## City of Ryde Submission

### BaptistCare Macquarie Park Masterplan- SSD-46561712

**Submission Date: 16 February 2023**

Figure 2: Extract from Landscape Design Report outlining proposed Open Space (Source: Appendix N, Page 31)

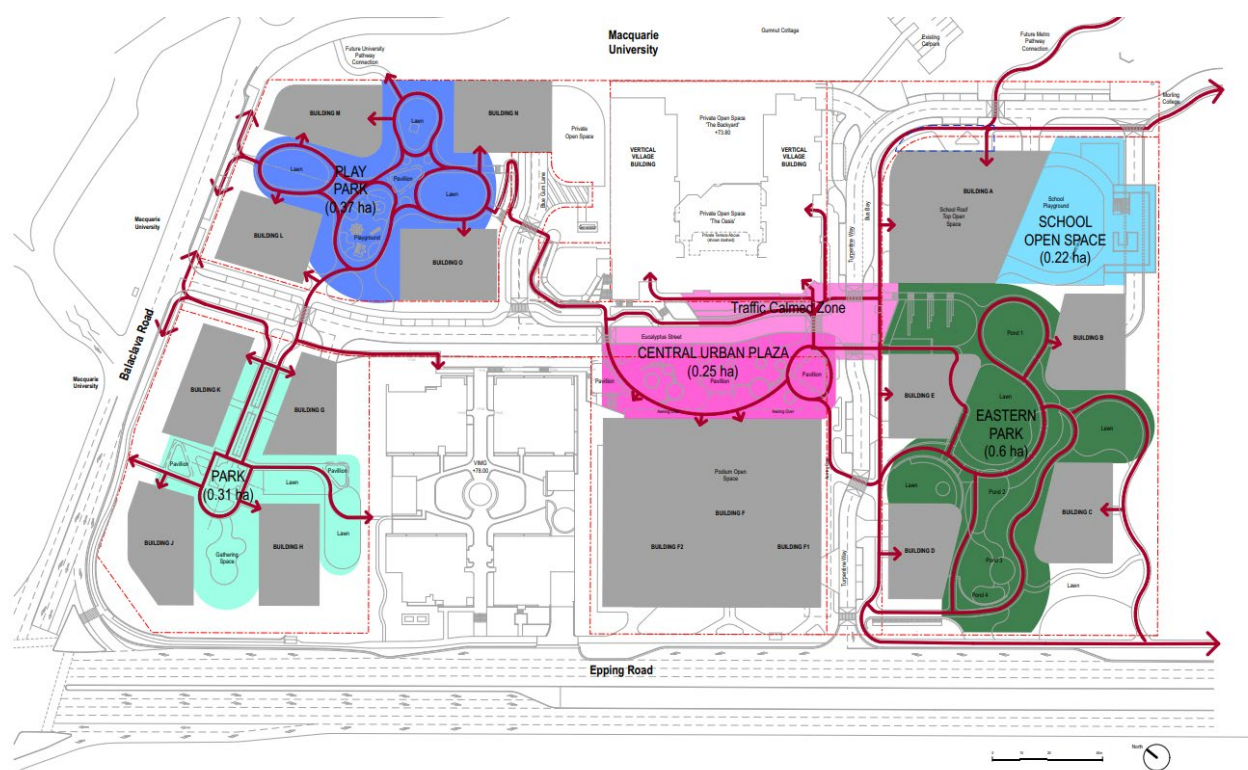
- Applying the open space requirements of 10m<sup>2</sup> per student would equate to 10,000m<sup>2</sup> of open space. In review of Appendix N Landscape Design Report, it is suggested that there is 0.22 ha (2200m<sup>2</sup>) of open space allocated to the school (Figure 2), this results in an unacceptable shortfall of open space allocated to the school. Additional open space should be allocated to the school or a reduction of students to match the proposed open space is recommended.

- The Applicant should consider the location of elements within the school open space that could also be made available to the general public such as basketball/multi-purpose courts. These should be located on the ground plane and made available outside of school operating hours as this would provide a wider benefit to community members in the precinct.

Figure 3: Mark up of Appendix N (Base Source: Appendix N, page 30)

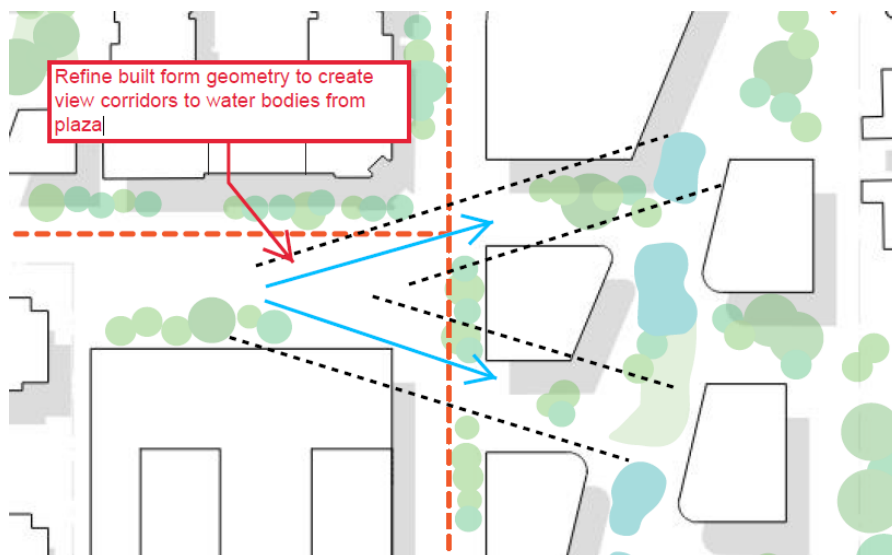
- The geometry and orientation of building envelopes need to be refined to improve the direct visual connections to the waterbodies from the civic plaza (see Figure 3).

Figure 4: Mark up of ADG Separation (Source: Appendix E page 70)

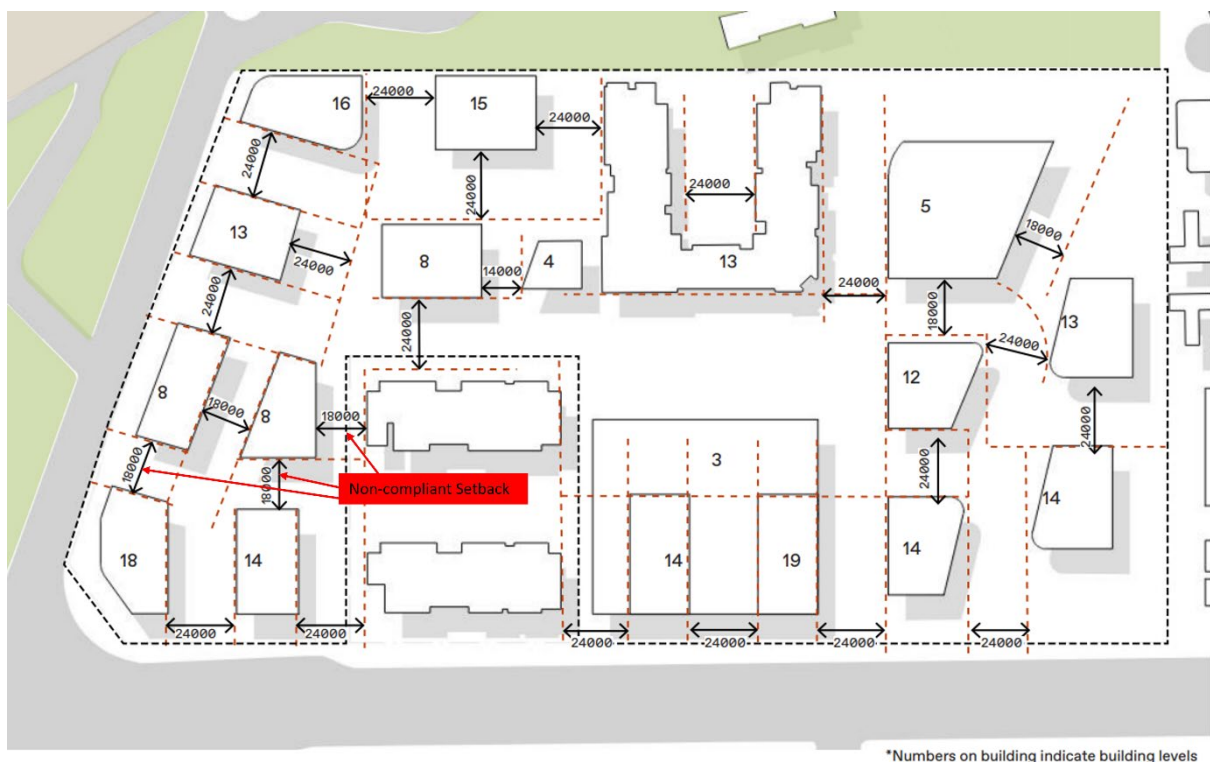
- The retail/commercial/conference centre component (Building F) should provide an active frontage to the north-south new street and a legible and activated corner presence to Epping Road. Considering that it is the entry point from Epping Road a more inviting arrival experience should be provided.
- In review of the setbacks proposed under Appendix E, the Masterplan proposes buildings that are non-compliant with the ADG building separation distances. The Applicant addresses this through alternative means such as building orientation to prevent direct sightlines and screening. This is however a poor planning and design outcome as it will result in compromised amenity for future residents. Of key concern are the proposed setbacks of superlot 9 (Figure 4). Further clarification on building separations and building siting is required and compliance with ADG is required.

Figure 7: Diagram of Proposed Lot E8 (Base Source: Macquarie University Design Excellence Strategy and Urban Design Guidelines, page 203)

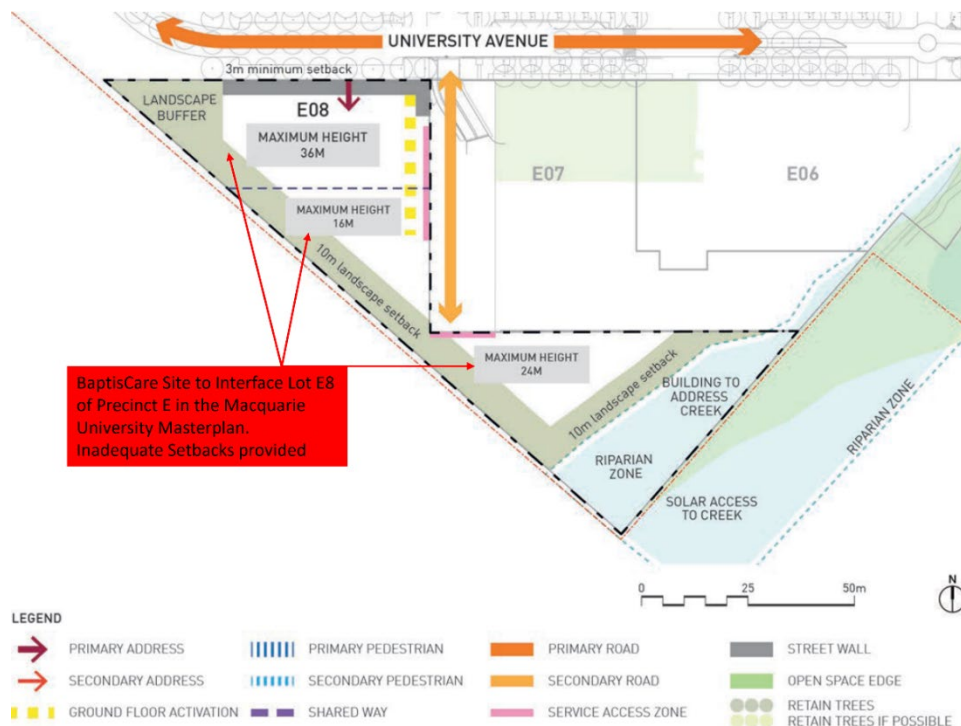
- Figure 7, shows the proposed built form of Lot E8, which will be directly facing superlots 1,3 and 4. The built form proposed on the northern boundary, facing the future built form of Lot E8, will create unacceptable amenity impacts on the future buildings on Lot E8. Further separation from the northern boundary is required and the ADG separation distances should be applied.
- The current Masterplan has not considered the future built form of surrounding sites adequately and further information is required to address the future built form outcomes.

Figure 8: Proposed Stage 1 Road Works (Source: Appendix F page 8)

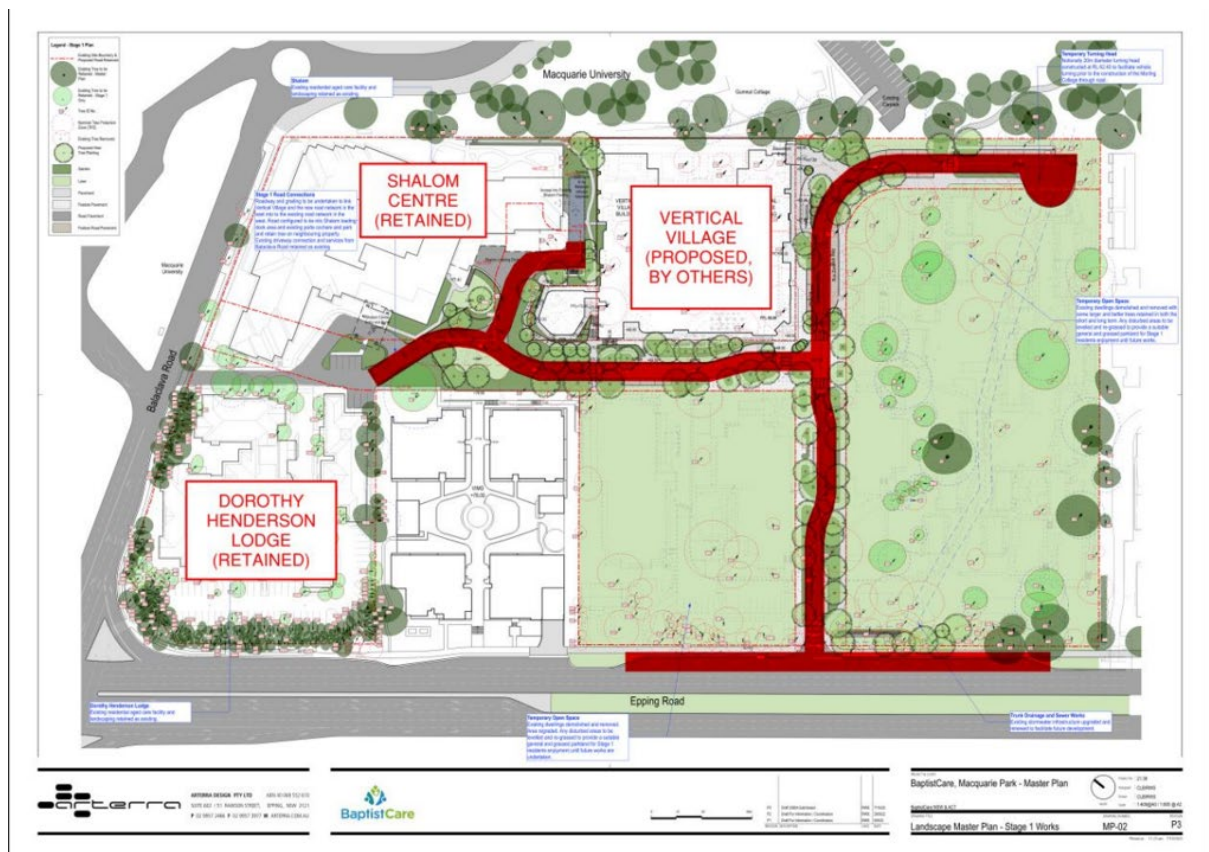
- In Appendix F Civil Concept Design, the Applicant is proposing Road 3 with a cul-de sac and no linking with the portion of Road 3 connecting from the Morling Collage site. The Applicant's Stage 1 works, show the road falling short of the connection from Morling Collage (Figure 8). Further clarification and design plans showing the connection with Road 3 from the Morling Collage site is required.

- The information provided does not demonstrate consideration has been given to the level difference between the subject site and the Morling Collage site with respect to connecting the Road. Additional plans need to be submitted demonstrating the connection can be made given the difference in ground level between these sites.
- Council notes that Appendix F includes “potential connection plans” (refer page 42, drawing reference C402) and this is not considered acceptable. If an agreement is not established between the Applicant and Morling Collage, Road 3 may not be constructed to connect to Balaclava Road. The Applicant is to provide details of further consultation with the adjoining

landowner in establishing an agreement to deliver Road 3 with additional plans showing the staged delivery of the Road 3 connection.

Figure 9: Figure 10 from Appendix U showing Expected Wind Conditions within the Proposed Masterplan (Source: Appendix U, Page 11)

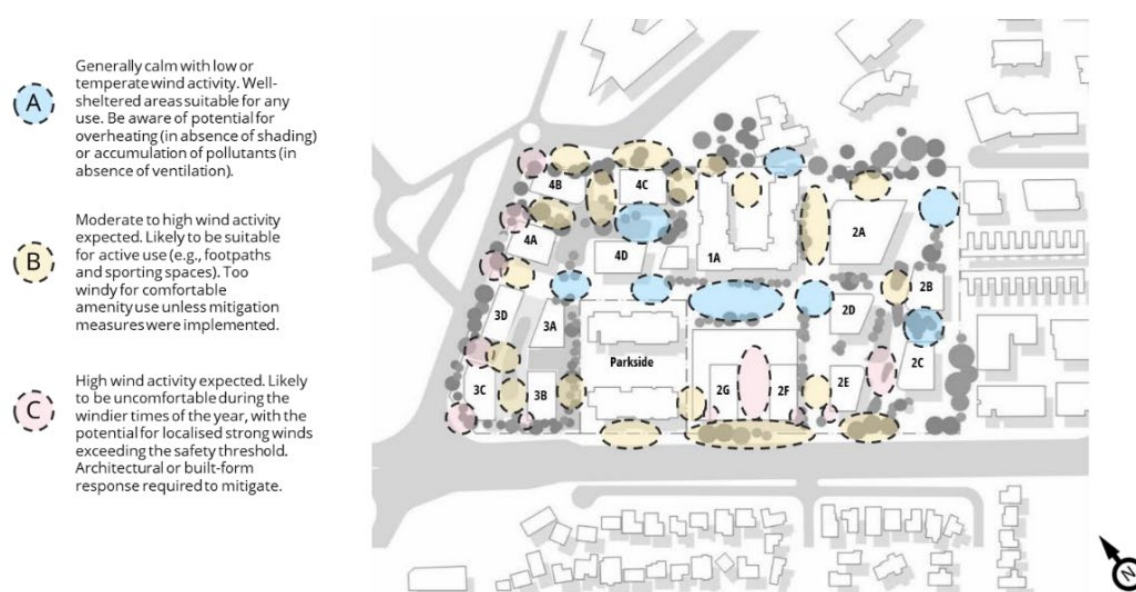
- The proposed point tower forms with unarticulated façades coming down to the ground increases the wind impacts on the ground plane. This is evident in the Wind Impact Assessment report (Figure 9) showing several locations will have a moderate to high wind activities, which is considered too windy for comfortable amenity use. The wind impacts at many locations along Balaclava Road exceed the safety threshold due to potential localised strong winds. Consideration should be given to having towers sitting above low-scale podiums with secondary setbacks to help mitigate the downwash winds; this is also recommended in the Wind Impact Assessment report.

Figure 12: Proposed GFA Plan (Source: Appendix E, Page 68)

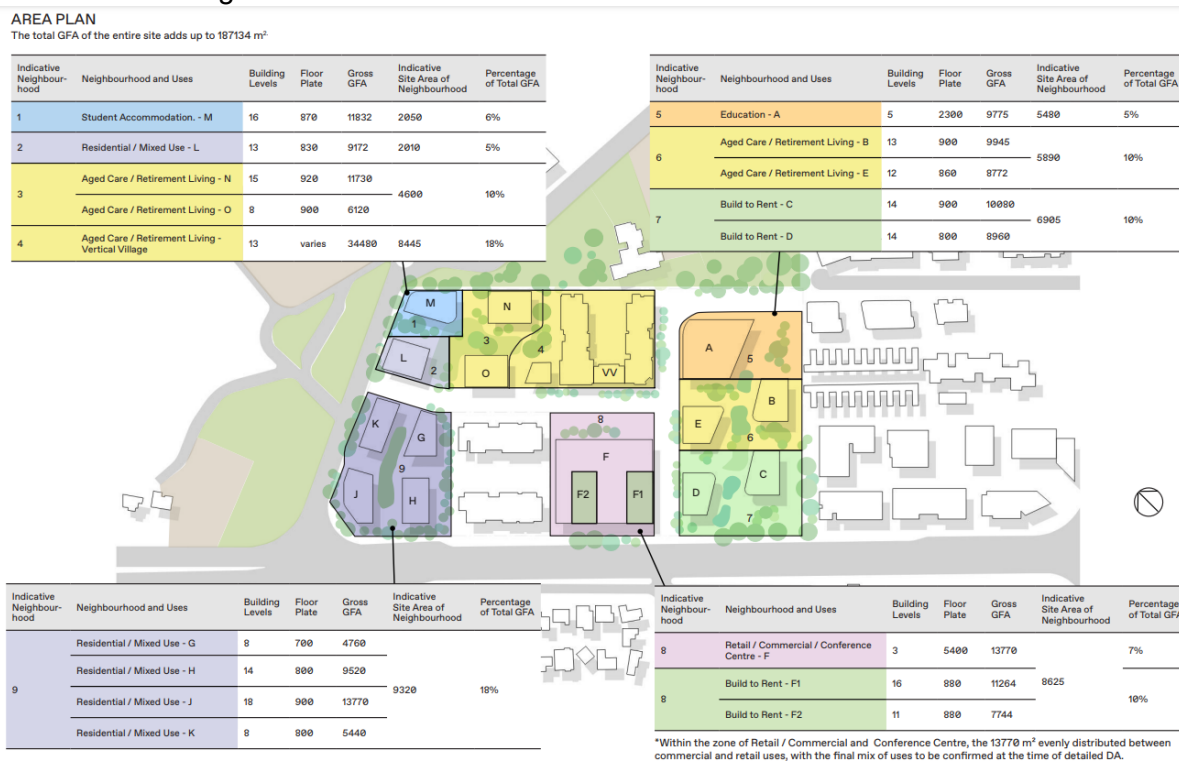
- The Masterplan seeks a maximum cap of 190,000m<sup>2</sup> of GFA allotted to the masterplan consistent with Figure 12.

- Council notes that an FSR of 2.5:1 would net a 160,000m<sup>2</sup> of GFA. However, the Applicant is intending to use FSR bonuses to achieve additional 30,000m<sup>2</sup> of GFA. Council requests a mechanism be imbedded into the SSD Application that ensures the additional GFA (If approved) is to be used for the specific purposes that trigger the bonuses. The Architectural plans should be amended to specify which uses are utilising the bonus GFA. If these uses are not provided in those locations, then the GFA should revert back to the maximum allowed with no bonus applied and the GFA removed accordingly.
- The Applicants calculations for GFA appear incorrect. Using Superlot 3 (Seniors living) as an example the following would apply:

- 4600m<sup>2</sup> (site area) x 2.5:1 (base FSR) + 25% (Bonus FSR) = 14,375m<sup>2</sup>
  - The Applicant has arrived at a figure of 17,850m<sup>2</sup>, which is 3,475m<sup>2</sup> higher than what would be permitted.
- The Applicant should provide detailed calculations of FSR, including how they ascertained their values. FSR should be calculated in accordance with Clause 4.5 Calculation of floor space ratio and site area of the RLEP 2014. Updated calculations (including methodology) identifying the correct GFA allocated to each superlot should be provided.

Figure 14: Markup of Architectural Plans (Base Source: Architectural Drawing Page 2)

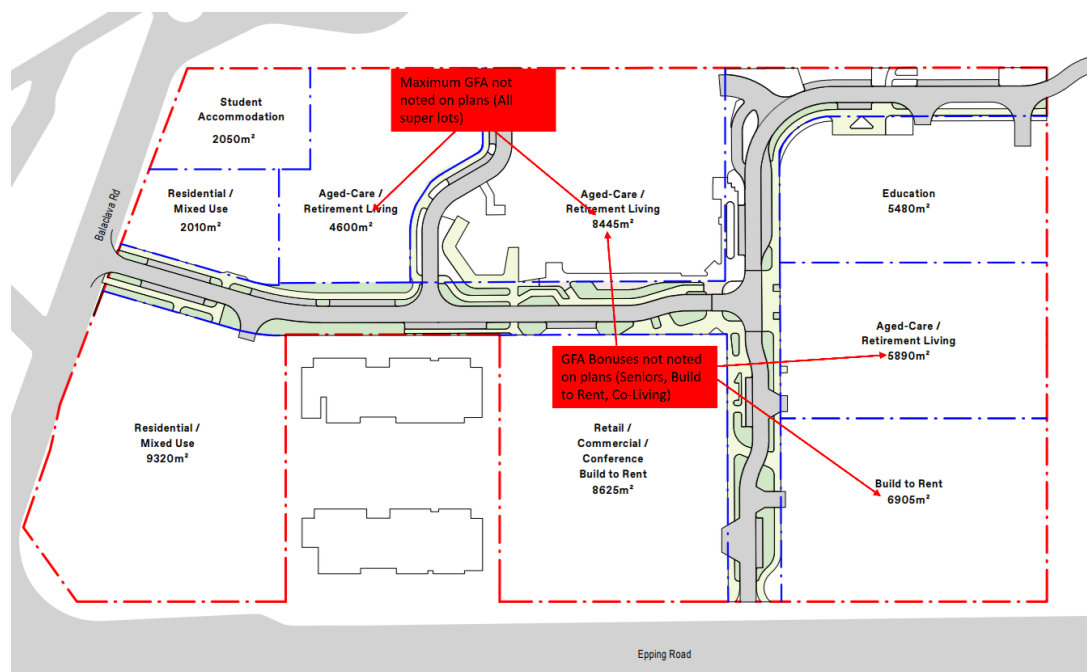
- The Applicant applies the proposed FSR as a total amount to the site, resulting in a proposed 2.93:1 FSR. However, in certain superlots, the FSR significantly exceeds 2.93:1, as shown in 13.
- It is recommended that an FSR/GFA portion plan (amended to correct calculation errors in the current proposal) is provided on the Architectural Plan Set, outlining the suggested GFA allocated to each superlot to guide future development (an example of this is shown on 14). Including this on the Architectural Plans would provide greater clarity around future applications for built form outcomes on the sites

Figure 13: Proposed Deep soil Zones (Source: Appendix N Landscape Design Report)

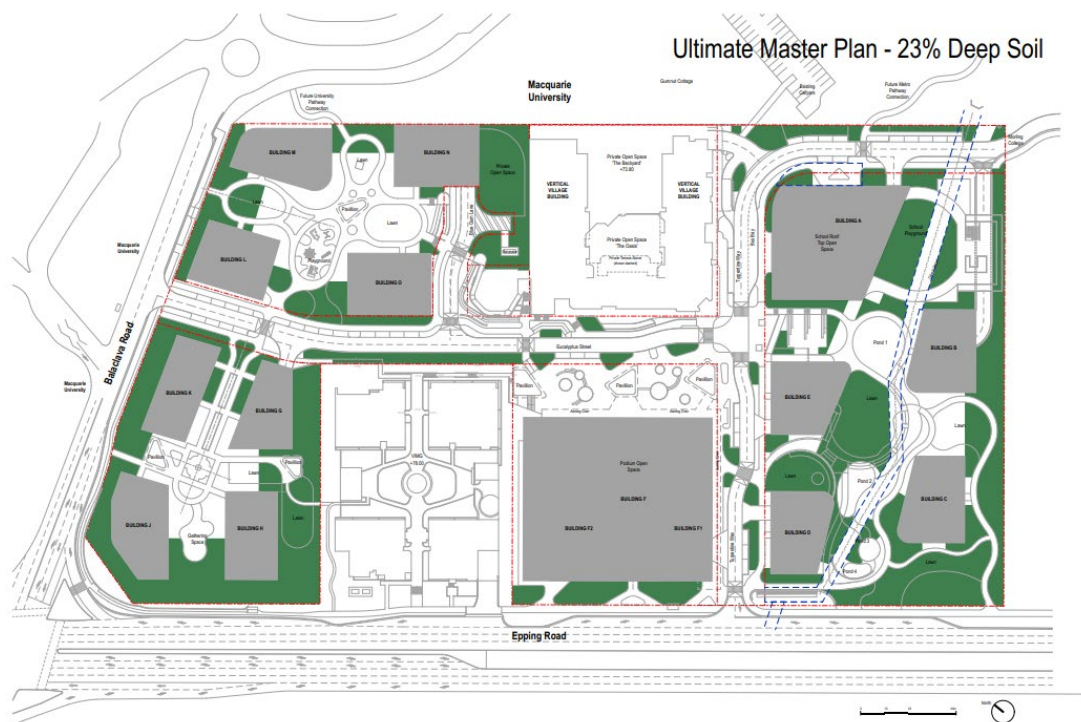
- In the Deep Soil Area diagrams within the landscape plans, calculations noting compliance with the minimum 20% are inaccurate given the inclusion of numerous areas which do not meet the minimum dimensions to be classified as deep soil.

- The overall lack of large, consolidated areas of deep soil across the site is unacceptable for the scale of the development resulting in a poor landscape outcome for the development, which fails to meet the deep soil objectives outlined in Section 8.2 of Part 4.5 of RDCP 2014.

- In addition to the above, the Vertical Village component of the proposal appears to provide no deep soil area (Figure 15) given the likely extent of the basement and podium. This fails to achieve compliance with the Section 3E of Part 3 of the ADG.

Figure 14: Diagram showing Intersection treatments for separated (on-road) one-way cycleways. (Source: City of Ryde's 2022 – 2030 Bicycle Strategy & Action Plan – Table 3)

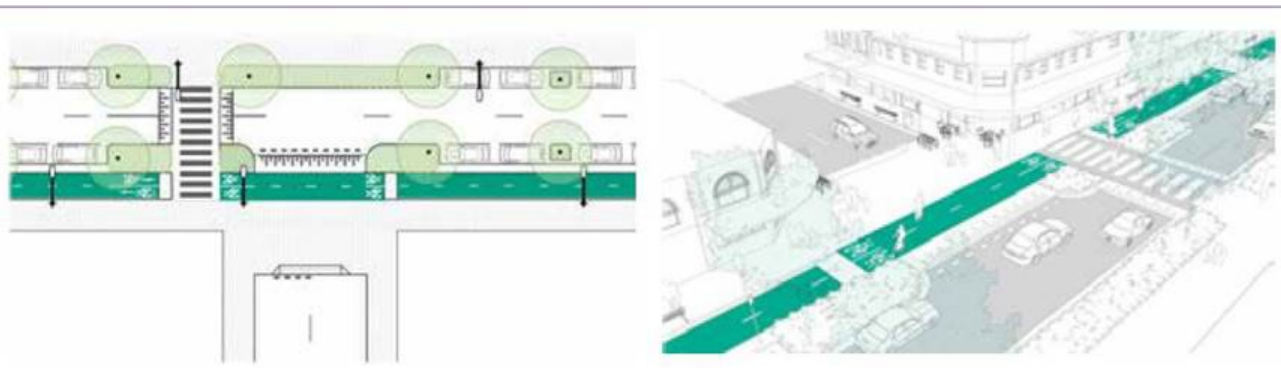
- Dedicated on-road cycle path separate to the live traffic along the eastern/southern side of Balaclava Road between Epping Road and the northern property boundary. The following Diagram (Figure 16) illustrates the preferred on-road cycle treatment in accordance with the Bicycle Strategy & Action Plan:

- Cycling crossing facilities across Epping Road at its intersection with Balaclava Road.

Figure 15: Road 3 Alignment Markup (Source: Ryde Council DCP )

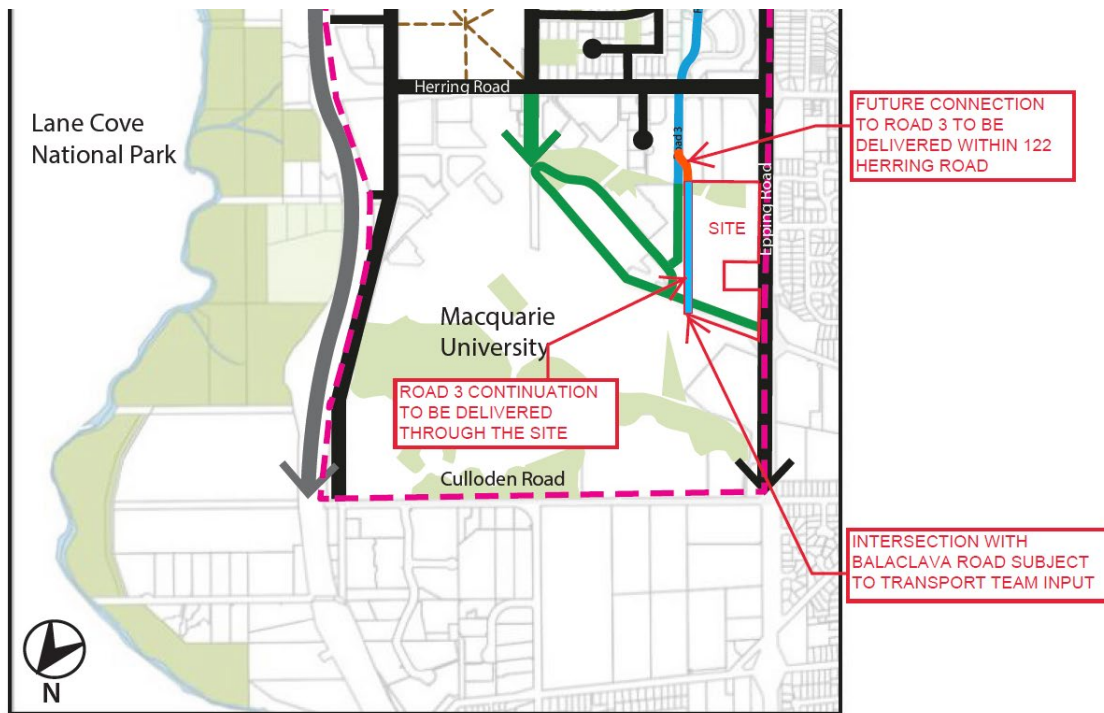
- Council's Development Control Plan details future road connection between Herring Road and Balaclava Road, via Road No.3 running through adjoining site 122 Herring Road and extending along the northern boundary line of the subject site and Macquarie University.
- The DCP specifies the new road should be 20m wide, refer Figure 17. The Road 3 continuation should be designed to public road requirements and dedicated to Council within the final stage of works. The proposed Road 3 continuation will need to tie into the portion of Road 3 that will be built under LDA2019/264 for 122-126 Herring Road.
- A typical street layout for 20m wide streets is presented in Section 6.0 of the Public Domain Technical Manual and is to be implemented in the design.

- Plans submitted with the EIS and Civil Design Report (Appendix F) appear to have abandoned the alignment specified in the DCP and shown above. The plans indicate an alignment turning toward the central part of the site and extending toward Balaclava Road along the alignment of the current private road known as Eucalyptus Street as per Figure 18:
